License No. 07-01173-03
Docket No. 030-14700
Control No. 16383

Lehigh Testing Laboratories, Inc.
ATTN: Leonard A. Weston
Vice President & General Manager
4029 New Castle Avenue
Wilmington, Delaware 19899

This is in reference to your application dated November 30, 1983 to renew License No. 07-01173-03. In order to continue our review, we need the following additional information:

ATTACHMENT A

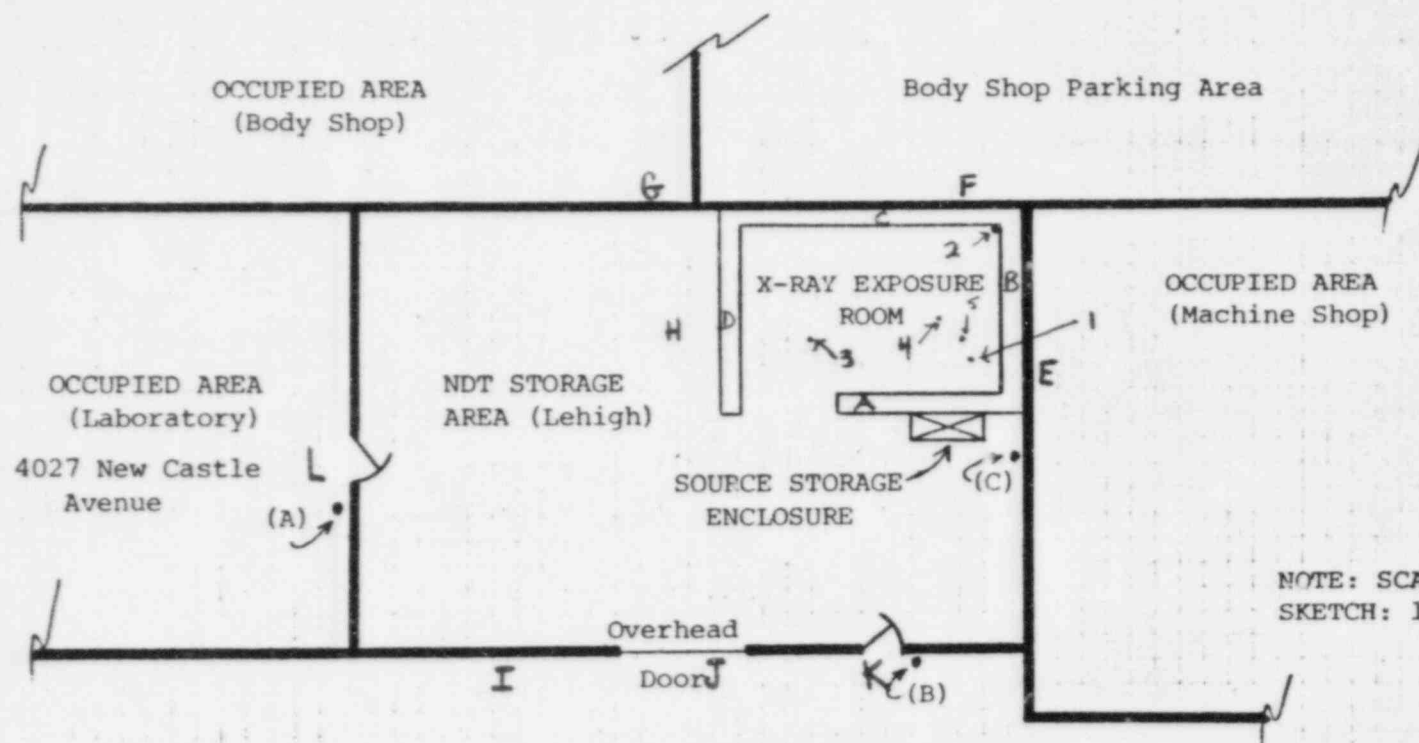
Our results (see Attachment B) indicate that radiation levels up to 936 mR/hr are possible in areas (see Attachment A) that should be unrestricted; additionally using our parameters the roof at a point 30 feet from the source had calculated radiation levels of 578 mR/hr. With the use of your Model 714, 654 or 799 collimators with the beam pointed at the floor, you could reduce this level to 8.25, 2.9 and 3.6 mR/hr respectively.

4. In our recent inspection it was observed that an individual could enter the x-ray exposure room without setting off an audible alarm if he entered the doorway at the end of wall A (see Attachment A). Please indicate, how you will correct this problem to comply with NRC regulations.
5. Please indicate the type, thickness and density of shielding materials used in the doorway, roof and floor of the x-ray exposure room, if any.
6. Please submit, any step by step instructions you will impose on radiographic operations in your current facility to assure radiation levels of 2mR/hr in unrestricted areas (e.g. always use the model 654 collimator with beam directed at the floor with source at least 4 feet from the walls in the corners abutting the machine shop).

Our calculations show that radiation levels as high as 578 mR/hr can exist on your roof (30 feet from floor/100 Ci source/no collimator used/beam panoramic) and at points 6 feet into the driveway and parking area from the garage door (30 feet from 100 Ci source to unrestricted area with no shielding on source or in doorway of x-ray exposure room). Additionally dose rates of up to 936 mR/hr can exist in the machine shop, the body shop parking area or at any point along the 16 inch wall of concrete surrounding your x-ray exposure room under specific conditions, e.g. 100 Ci source placed against wall/no shielding of source.

3. In light of the NRC's calculations, please indicate, how you will limit the radiation level to 2 mR in any one hour in the unrestricted areas surrounding your radiographic facility such as the machine shop, the body shop parking area, the roof of your building, and the driveway and parking area. Please note,

ATTACHMENT C

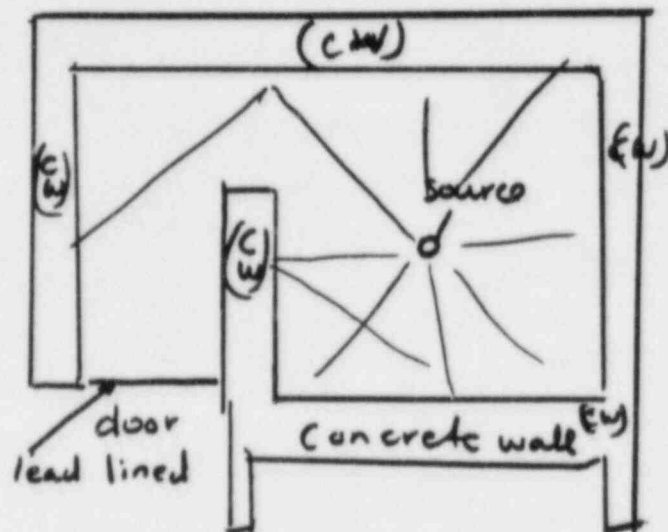
1. An annotated sketch or drawing of the facility and its surroundings which show:
 - a. The scale to which the sketch or drawing is made (the same scale should be used for all sketches and drawings). The recommended scale is $\frac{1}{4}$ inch = 1 foot. The facility lay-out should include a maze at the entrance (see Attachment C).
